# Town of Mammoth Lakes

## Advisory Design Panel Staff Report

| <b>Date:</b>                 | January 15, 2019   | <b>File No.:</b>      | Major Design Review (DR) 18-006    |

**TITLE:** Yotelpad Design Review

| F.0   | Shadow Study                   |

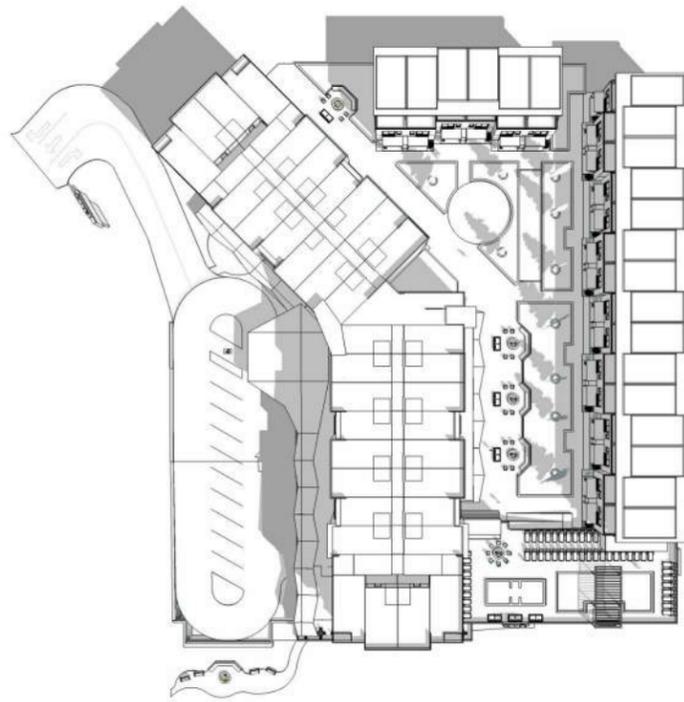
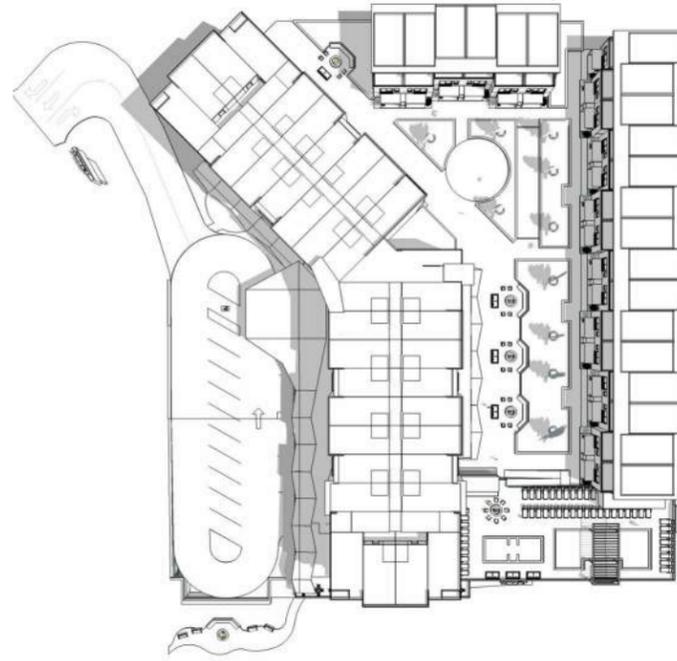
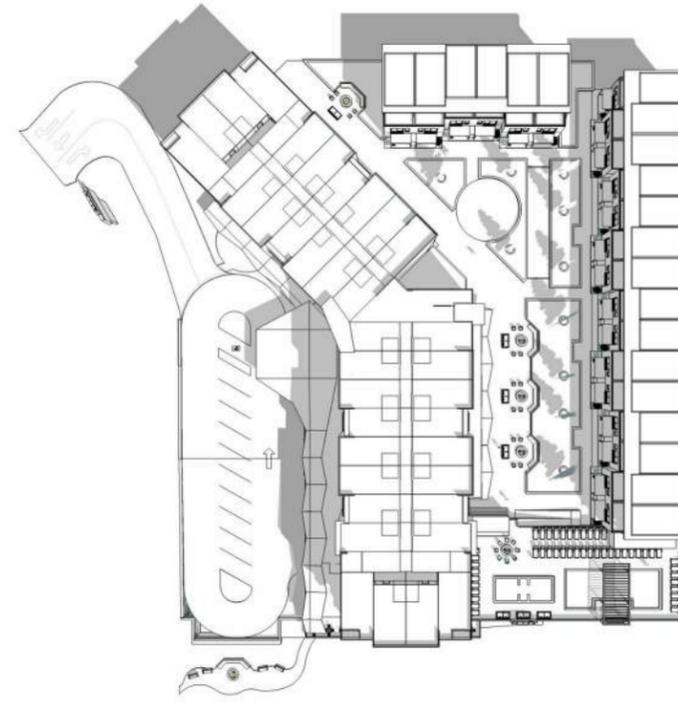
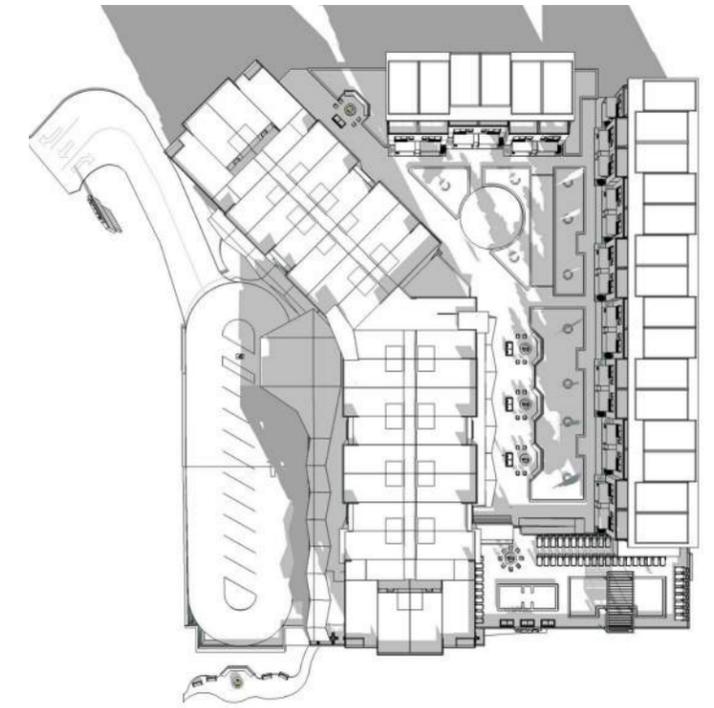
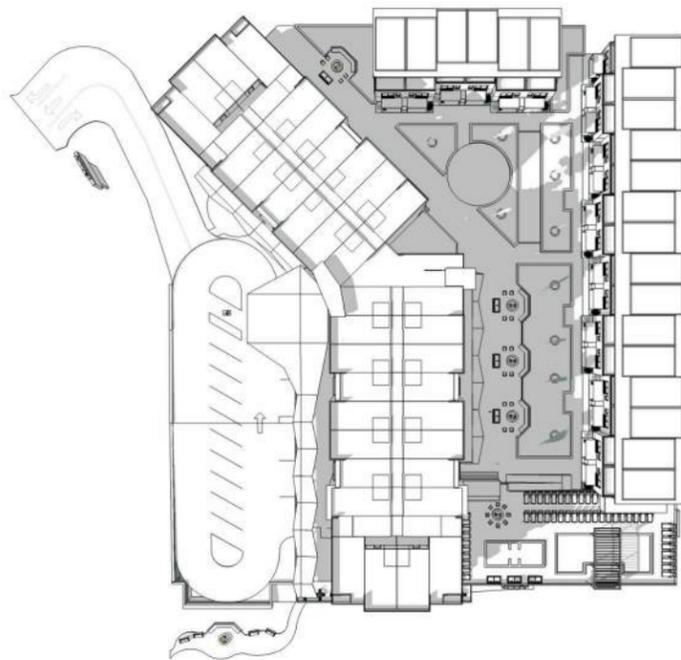
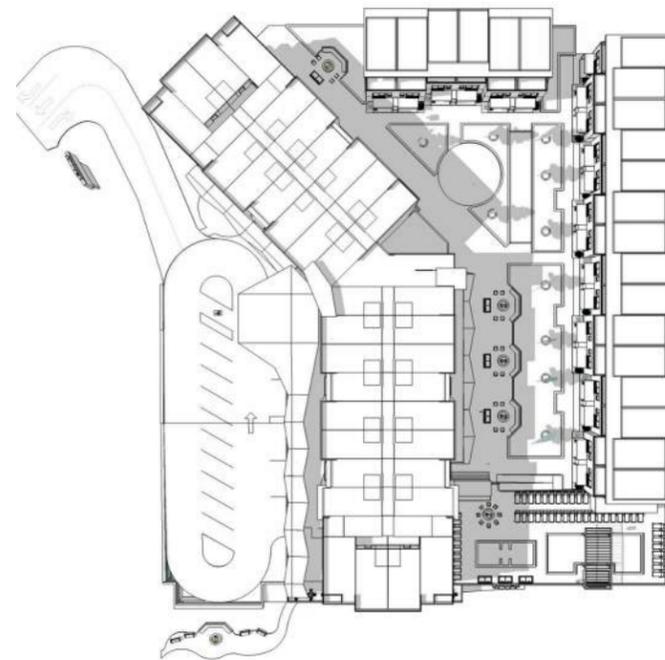
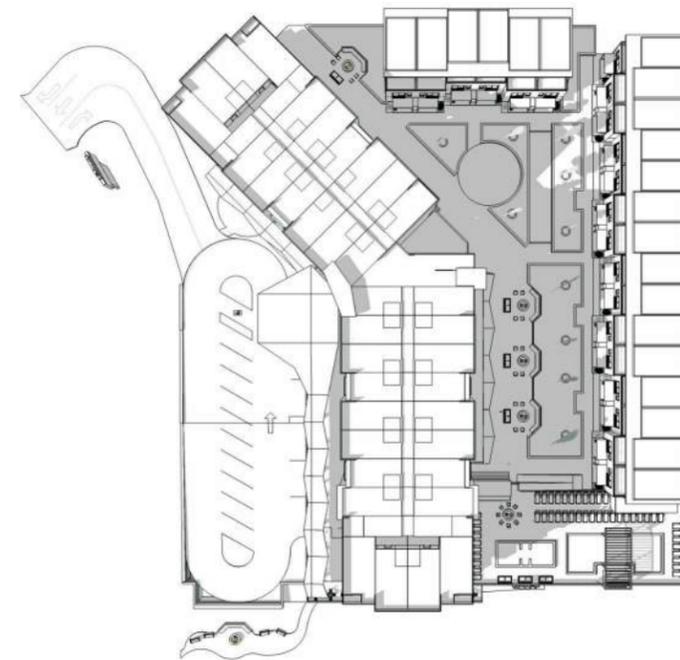
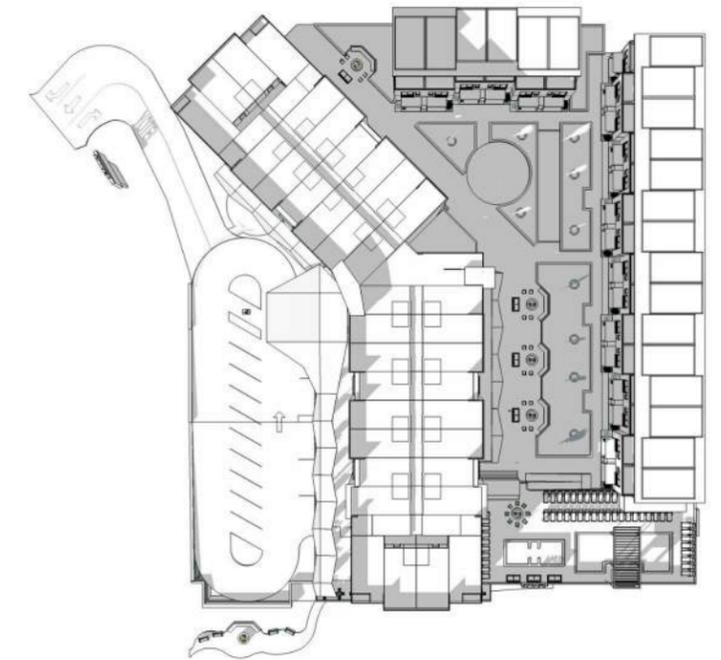
- *The design of buildings should preserve sunlight into public places.* Shadows are minimized by placing the larger building in a north to south configuration and placing the smaller buildings along the northern and eastern sides of the property. See the Shadow Study (Attachment 2, Sheet F.0) for the modeling of the anticipated shading that will occur.
